Panel Reference	PPSHCC-22
DA Number	DA2019/01169
LGA	Newcastle
Proposed Development	Mixed use development - demolition of structures, erection of two 14 storey mixed-use buildings with shared basement carparking (285 spaces), comprising seniors housing (114 bed aged care facility and 82 independent living units), residential flat building (166 units), medical centre, food and drink premises (cafe and restaurant) and retail premises (salon).
Street Address	309 King Street Newcastle West (Part Lot 1 DP 826956)
Applicant/Owner	Western Suburbs (Newcastle) Leagues Club Ltd
Date of DA lodgement	06 November 2019
Number of Submissions	Nil
Recommendation	Approval

Background

Figure one: Longview section

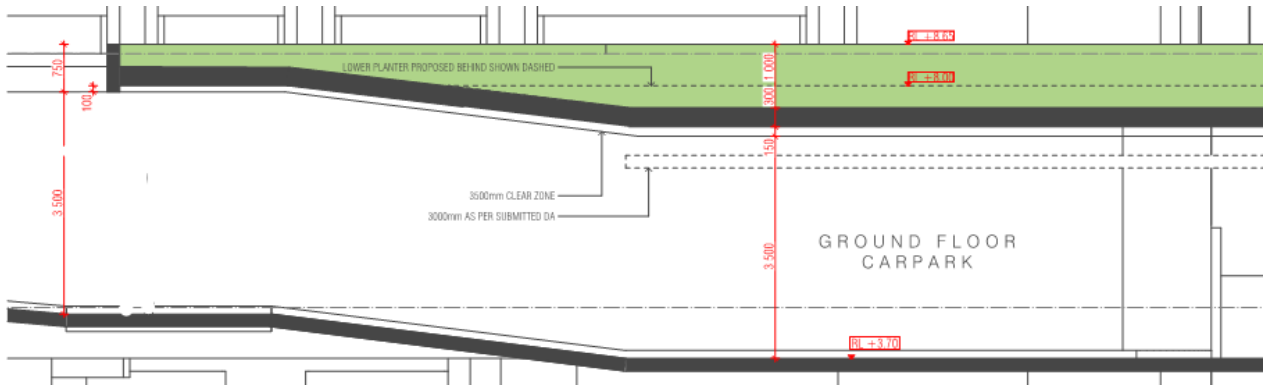
The amended plans prepared by Fender Katsalidis include changes to Ground Floor Plan (SK-020.5) and First Floor Plan (SK-020.8). Supporting section drawings indicate a satisfactory response to the required clearance of 3.5 metres on entry and into the loading manoeuvring area. The amended access for clearance to 3.5 metres is compliant with AS/NZS 2890.2.2004 (refer to Figure One, Two and Three).

Figure Three: Ambulance Parking and Loading

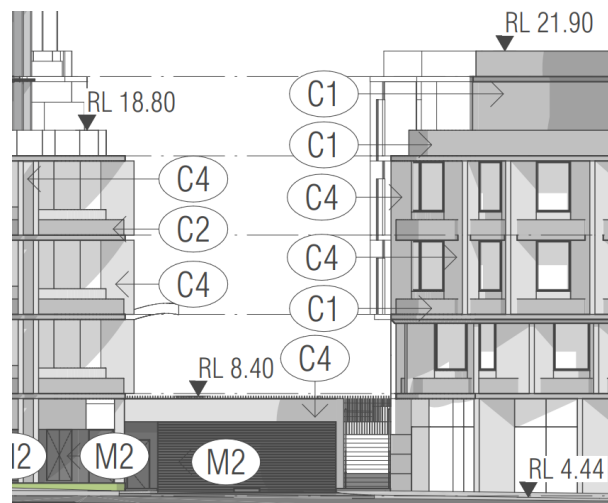
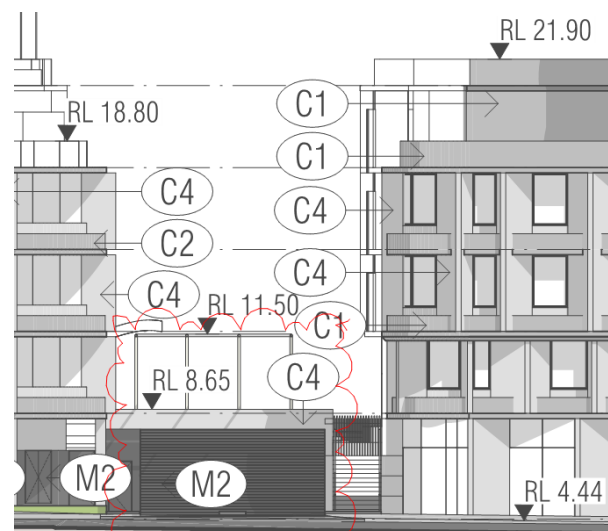
In addition, amended sweep path plans (Prepared by GHD and Drawing No. A1) have been submitted in relation to the King Street access. There is a minor conflict of the largest vehicle entering the building and with the median strip at the access of the property. As discussed in the previous report, minor modifications are required to the driveway access design along the eastern side to ensure the largest expected vehicle can enter/exit the site. A condition of consent is considered an appropriate means to addressing the matter as the construction detail shall be submitted through the s.138 Roads Act Approval process. In order to ensure the conflict is addressed the below recommended condition shall remain:

A commercial vehicular crossing is to be constructed across the road reserve, in accordance with the following criteria:

- a) *Constructed in accordance with City of Newcastle's A1300 – Driveway Crossings Standard Design Details.*
- b) *The full width of footpath pavement should be continuous without any kerb returns with maximum gradient of 2.5% along the development frontages.*
- c) *Letterboxes, landscaping and any other obstructions to visibility are to be kept clear of or limited in height to 1.2m, in the 2.0m by 2.5m splay within the property boundary, each side of the driveway entrance.*
- d) *The proposed driveway is to be a minimum of 3.0m clear of the trunk of any tree within the road reserve.*
- e) *The proposed driveway is to be a minimum of 750mm clear of the centre of any pole or obstruction within the road reserve and 1.0m clear of any drainage pit.*

Figure Four: Superseded plan – Level 1

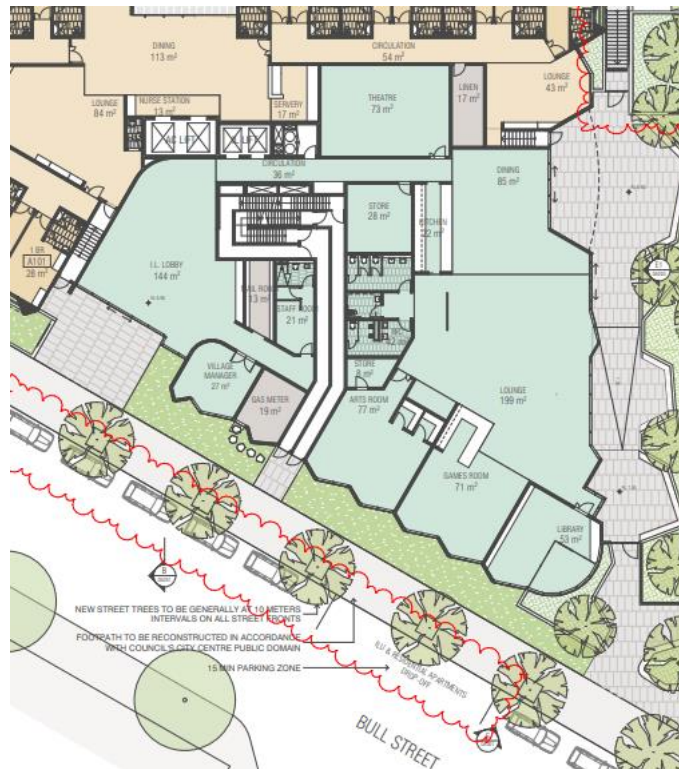
The new bin storage area on Level 1 has been facilitated through the reconfiguration of the Seniors Independent Living Unit (ILU) amenity rooms (storage room, toilets, lounge, arts room, games room and library). A reduction in the Senior ILU amenity areas from 558m² to 431m² has occurred. However, the amendments are not considered to have unreasonably impacted the communal areas which still exceed the minimum requirements. The Level One bin storage area with access to Bull Street enables CN to service the site collection.

The amended plans have not resulted in an increase to the proposed FSR. As detailed above, the waste storage / collection areas have been achieved through the reconfiguration of the existing floor plate by way of amendments to the Senior Living amenities (refer Figure Four and Five below). Further, storage areas are not included within the FSR calculation.

Figure Five: Level 1 Independent Living Unit (ILU) Courtyard area

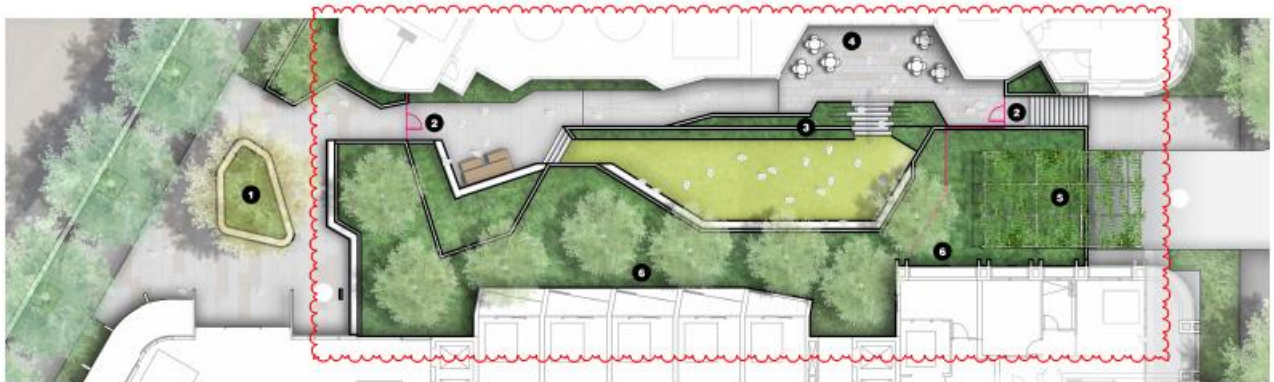
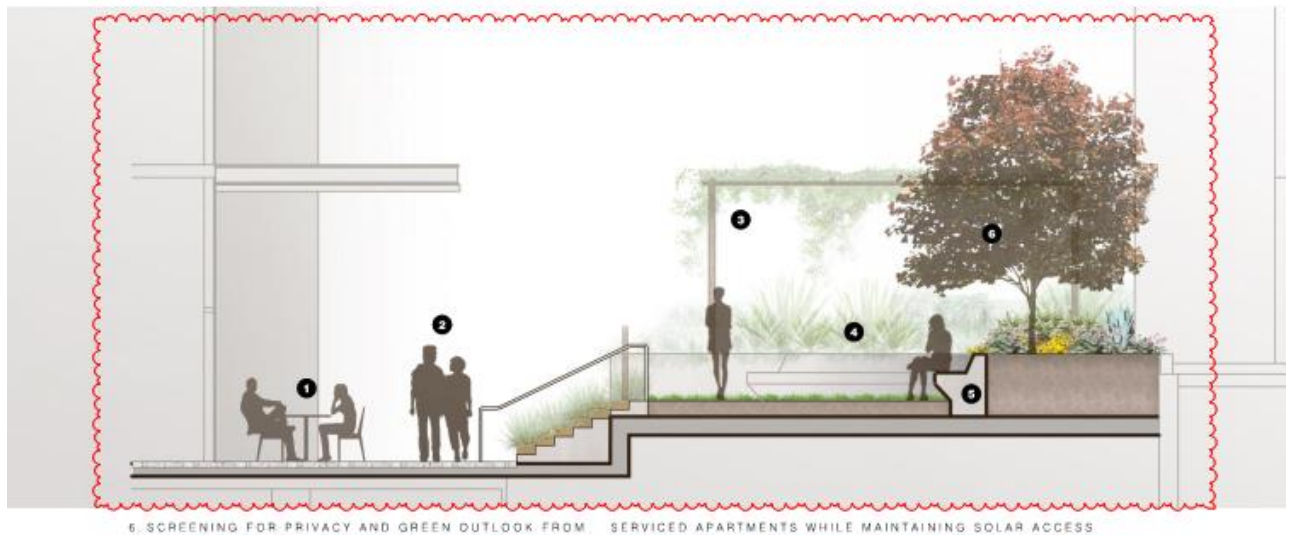
The change allowed for an improved amenity outcome for the Independent Living Unit (ILU) courtyard area. An increase in green space and landscape features increased green spaces associated with the design. The bin storage areas have been facilitated within the existing floor plates of the development. Therefore, there has been no compromise on the design quality outcomes including landscaping and communal areas.

The area incorporates increased landscaping and an addition of a pergola structure to incorporate greenery with vines. The pergola can be viewed from King Street, with an improved amenity outcome for this location (refer to Figure Six).
